**ACNW'S INTEGRATED  
STRATEGY TO  
EVALUATE THE STAFF'S  
LICENSING CAPABILITY  
AND SUFFICIENCY  
REVIEW**

**Dr. B. John Garrick  
Chairman, ACNW  
March 22, 2001**

# Some NRC staff requests:

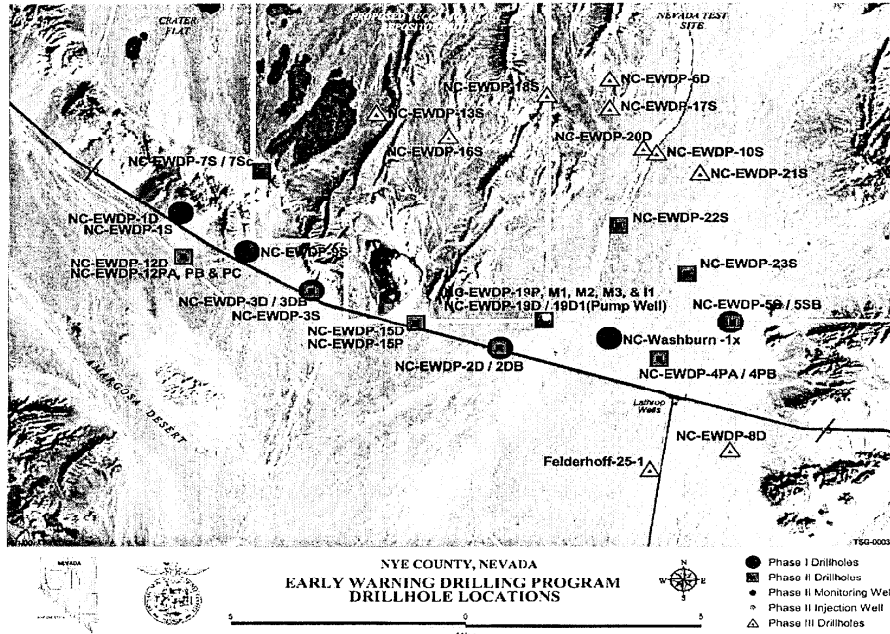
# Some NRC staff concerns about SZ flow:

- Anisotropy?
- Flow paths in alluvium?
- Alternative conceptual models?

- Detailed plan for alluvial testing
- Justification for uncertainty of paths
